BusConnects Dublin Core Bus Corridor Projects

Corridor 8 – Clondalkin to Drimnagh

Emerging Preferred Route – Public Consultation Report 2018/2019

Section 1: Nangor Road

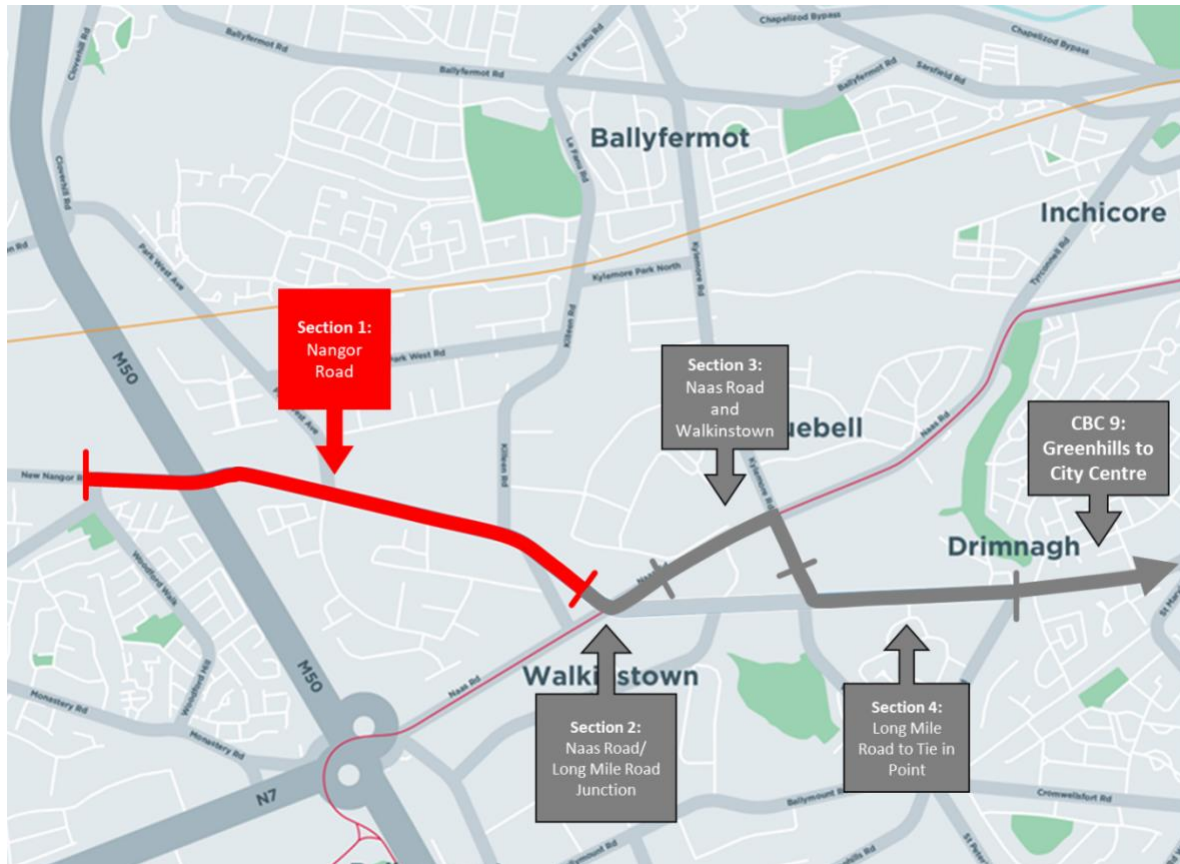
- The inclusion of shared spaces along Nangor Road is not welcomed by the public. Shared surfaces provide a low level of service for all users.
- Segregation for cyclists and pedestrians is crucial along Nangor Road in order to increase the attractiveness of active travel modes and the use of public transport.

- No segregation for motorists and cyclists at Woodford Walk Junction. Counter intuitive to segregate all along the route and then mix at junctions where they are most vulnerable.
- Bus stop bypasses have proven dangerous for pedestrians, particularly vulnerable pedestrians with disabilities. Reports from transport authorities in Copenhagen have proven this.
- Remove left turn slip lane.

- Provide bus stop bypasses (island bus stops) at all stops (Requested by Cycle Groups).
- In line bus stops are unacceptable and have proved to increased accidents by 1900% in Copenhagen.
- Proposal to change existing roundabout on Nangor Road / Riverview Business Centre entrance will be abused as cyclists stay on the path and use crossings with pedestrians.
- Shared space on the corner of Nangor Road/ Park West Avenue not appropriate and unsafe for pedestrians.
- Fully segregate cyclists at Business Centre entrances and provide buffer space turns to avoid HGV blind spots. Consider raised cycle tracks at junctions to allow priority for cyclists.
- All arms of the Oak Road/ Nangor Road/ Park West Avenue junction are secondary GDA CNP routes. It should be safe for cyclists to travel in all directions, so a fully segregated junction should be provided for here.
- Remove slip lanes.

- Is there a buffer separation between pedestrians and cyclists?
- Given that there is sufficient space provided at the Diageo Entrance on Nangor Road, a buffer space priority junction for cyclists should be considered.
- Irish Soft Drinks Ltd. Property backs onto Nangor Road at Map 4. Owner is not sure if the council ever purchased the land that currently Nangor Road runs on. There are existing drains that run under the property.

- The junction at Willow Road/Nangor Road doesn't provide proper segregation of motor traffic and bicycle traffic.
- Provide bus stop bypasses (island bus stops) at all stops.
- Four drive through bus stops all unacceptable from a safety position for all pedestrians and cyclists.

- Shared surfaces at pedestrian crossing at Killeen Road/ Nangor Road junction not welcomed.
- Sufficient space at outbound bus stop to provide a bypass for cyclists.
- Shared space at crossing will create a 'kill zone' for pedestrians.
- Remove slip lanes.
- Segregating cyclists from left-turning traffic needs to be strongly considered here.

Section 2: Naas Road/ Long Mile Road Junction

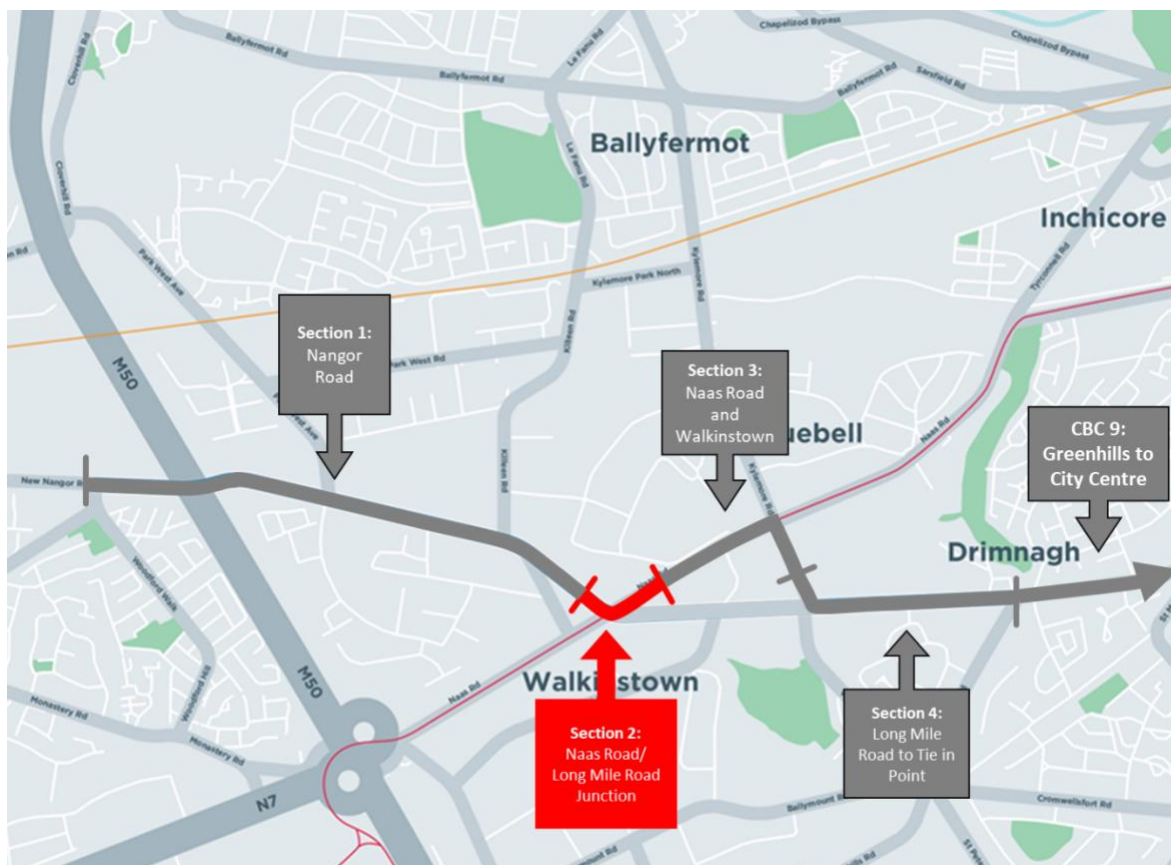
- Consider a Dutch-Style Junction with segregation provided for all road users.
- Toucan crossings are not safe for pedestrians, cyclists cross at speed, and refuse to dismount.
- Dublin Cycling Campaign refers to this junction as “a beast of a junction for cyclists”. A two-way cycle track will significantly reduce the number of crossings required for a cyclist.
- Install a buffer zone of 0.5 – 1m between two-way cycle track and carriageway on both sides of the road.
- Maps show that it takes 6 Toucan Crossings to cycle southbound into the junction and wish to cycle westwards.

Section 3: Naas Road and Walkinstown Avenue

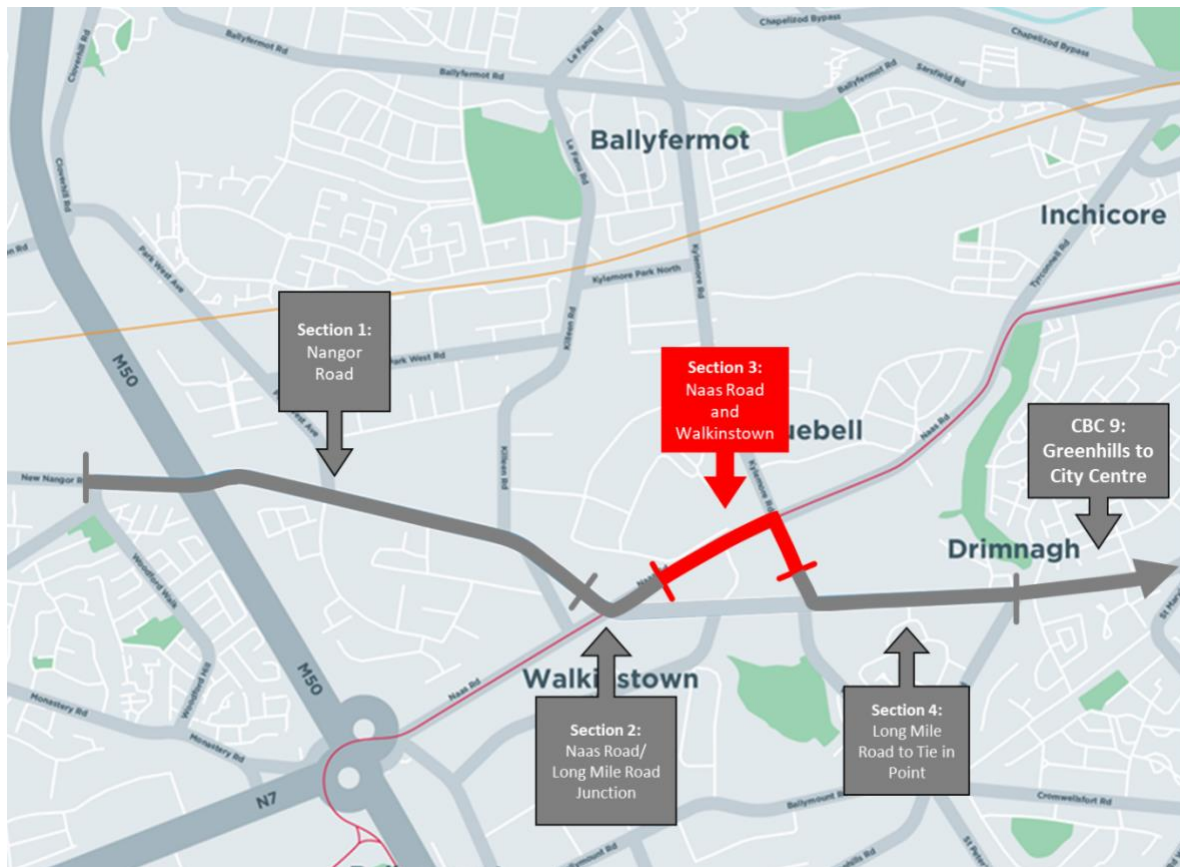
- Shared surfaces at pedestrian crossing at each junction are not welcomed.
- Inline bus stops are not adequate design for cyclists.
- Install a buffer zone of 0.5 – 1m between two-way cycle track and carriageway on both sides of the road.
- Consider reducing the road lane widths to 3m to allow for a 0.5m buffer space between cycle lane and road on both Long Mile Road and Walkinstown Avenue.

- Shared surfaces at pedestrian crossing onto John F. Kennedy Drive not welcomed.
- Island bus stops are both too small and badly designed with poor tactile information. There is no method implemented to slow cyclists before the bus stop.
- Provide a raised table to avoid HGV blind zones at Harris Warehouse entrance.
- Install a buffer zone of 0.5 – 1m between two-way cycle track and carriageway on both sides of the road.

- Shared surfaces at pedestrian crossing at Naas Road/ Walkinstown Avenue Junction not welcomed.
- Provide for bus stop bypasses at all bus stops, where there is ample space available.
- Kylemore Luas Stop: Add bike parking to facilitate multi-modal transport use.
- Proposed changes to the Walkinstown Avenue Junction include the provision of a right turn from the existing bus lane on Naas Road onto Walkinstown Avenue. The complexity of the signalisation and the interface with Luas operations through the junction has the potential to negatively impact Luas safety and efficiency.

Section 4: Long Mile Road to Tie in Point with Greenhills to City Centre Route

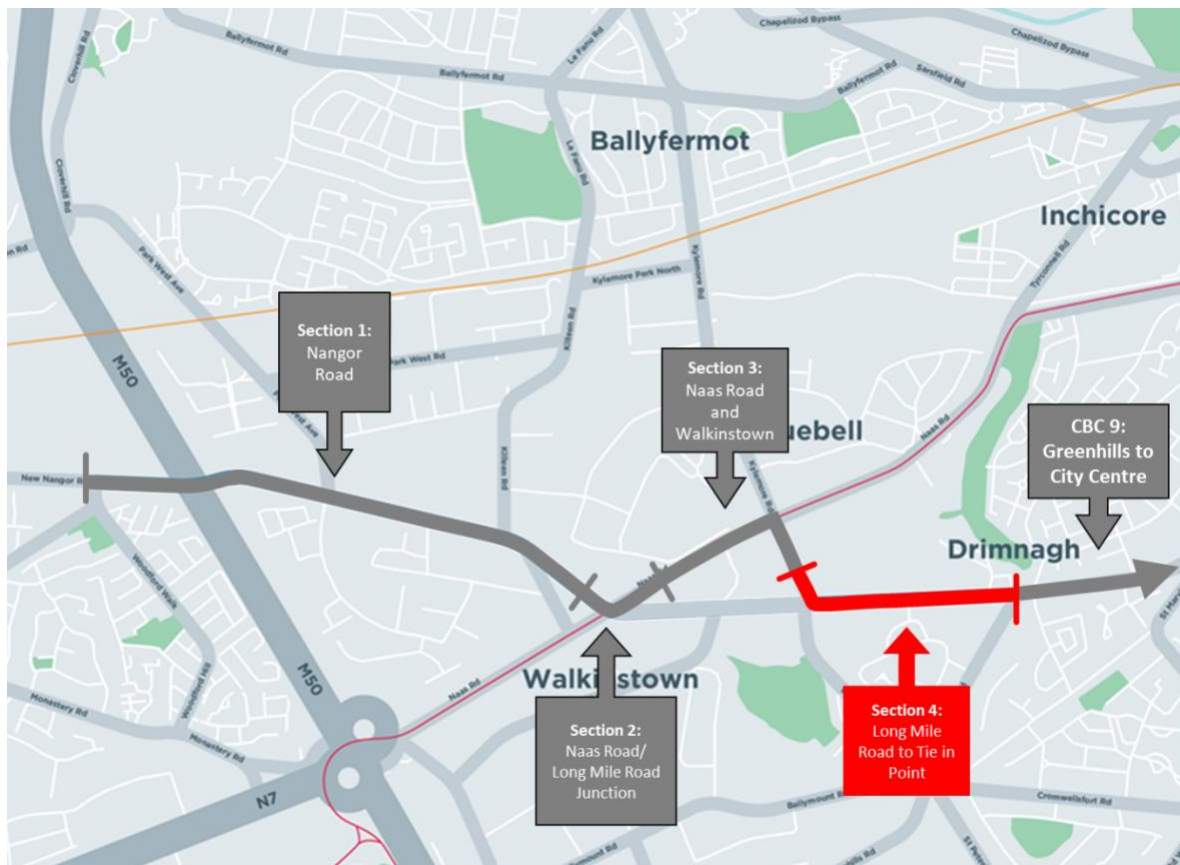
- Consider reducing the lane width to 3.5m to allow for a 0.5m buffer space between cycle lane and road on both Long Mile Road and Walkinstown Avenue.

- Shared surfaces at pedestrian crossing at Long Mile Road/ Walkinstown Avenue Junction not welcomed.
- Provide for bus stop bypasses at all bus stops, where there is ample space available.

- Walkinstown Parade/ Long Mile Road Junction doesn't provide proper segregation of motor traffic and bicycle traffic.
- Provide bus stop bypasses for cyclists where there is sufficient space (Long Mile Road).
- Remove Toucan crossing here, will only cause hazards for pedestrians crossing as they mix with fast approaching traffic.

- All junctions on this map do not provide proper segregation of motor traffic and bicycle traffic.
- Bus stop bypasses should be provided where there is sufficient space.
- Inbound bus stop lengthened which may cause problems for buses turning onto Long Mile Road to get parallel to the stop for ramp access.
- Major issue with parking on footpaths outside houses 133 – 147.
- Inbound bus stop has been lengthened which may cause problems for buses turning onto Long Mile Road to get parallel to the stop for ramp access.

Multiple Sections throughout the Scheme

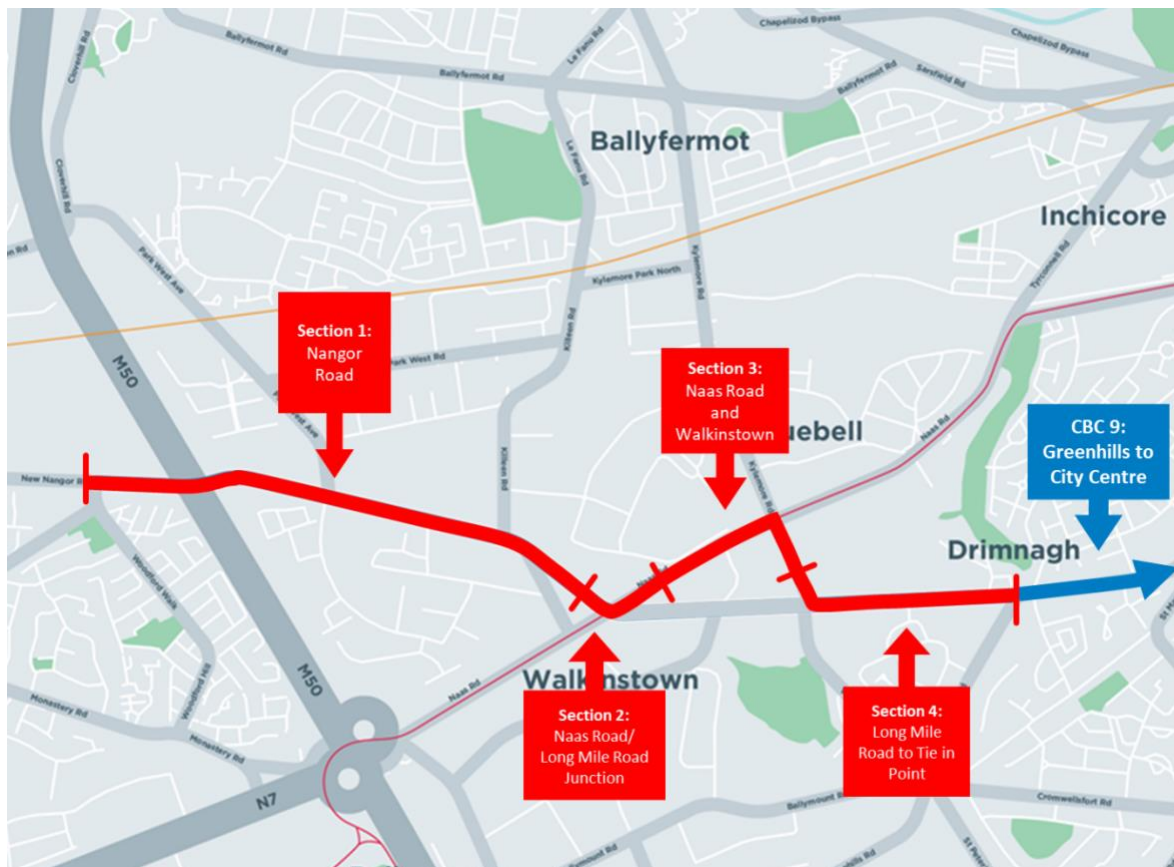
- Disagreeing with the proposal to require passengers to change of bus from one route to another in order to get from Clondalkin (current routes 13 and 151) to the City Centre.

- Plans do not show how cycle lanes return to the carriageway safely.
- This area of Dublin currently is incredibly hard to cycle around due to the large roads, heavy traffic, high speeds, and large number of heavy goods vehicles (HGV's). The design of the junctions and the entrances to some of the large industrial or retail parks will be important.

- Removal of turning slip lanes, not compliant with section 4.4.4 of National Cycle Manual.
- Better design of junctions and entrances to limit the danger of Heavy Good Vehicles (HGV's) crossing cycle paths.

- Uncontrolled junctions for persons With disabilities are useless particularly for the vision impaired or blind pedestrian.
- Is there a buffer separation between pedestrians and cyclists? It is clearly stated what height path is required to achieve a safe separation, but has been ignored by NTA, DCC, Fingal and South Dublin CC. The proposed height of 50mm is not acceptable as it is a trip hazard and is impossible to be used by guide dogs or long cane users as an indicator.

- The hierarchy of design puts pedestrian above cyclists and public transport, however this design turns that around completely. As designed, it will stop vulnerable pedestrians from using the public transport service and isolate them even more than they already are.

- Roads need to be widened.
- Traffic lanes must be converted to bus lanes.
- On-street parking and loading bays will be removed or reduced.
- Cycle routes need to take the journeys cyclists actually wish to take into consideration (desire lines).

- Introduce a congestion charge.
- It is ironic that while on the one hand we claim to be in favor of making the city more Age Friendly, many of the changes in bus provision will negatively impact on the options elderly people and people of reduced mobility have.

- Consider the use of protected Junctions.
- The design should ensure that space for pedestrians is provided and preferably, enhanced at all stages of the route.

- Integration with proposed connecting Greater Dublin Area Cycle Network Plan Routes.
- Cycle lanes should not end suddenly, and “the squeeze” should never occur (where the road is narrower after the junction).
